SEWAGE DISPOSAL SYSTEM

DEPARTMENT OF HEALTH AND MENTAL HYGIENE

P 514931

SUBDIVISION The Knolls LOT 8 ROAD 3515 Shady Lane

P 514931

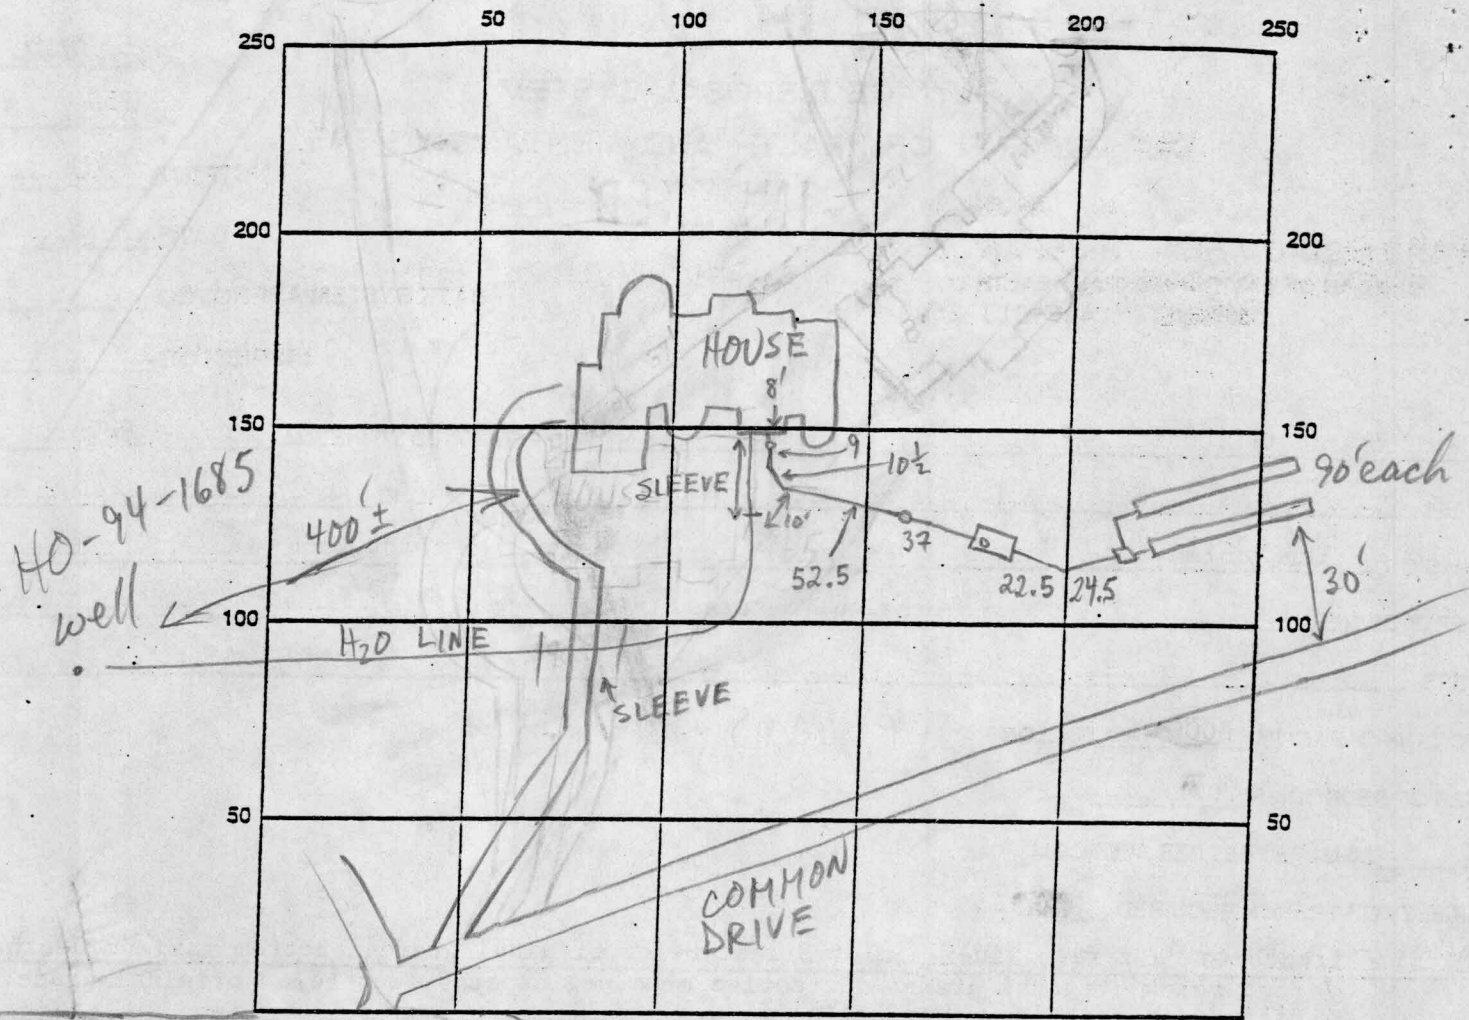
REMARKS: 3/8/01 layout confirmed - SDA staked - OK to run 2-90' trenches and set distribution box at one end of SDA. DIC

3/9/01 First trench done. Tank set. To leave end of second trench open for inspection on Monday. First trench ~10" deeper than intended in order to make fall from house. (BB)

3/12/01 OK TO COVER ALL (MR)
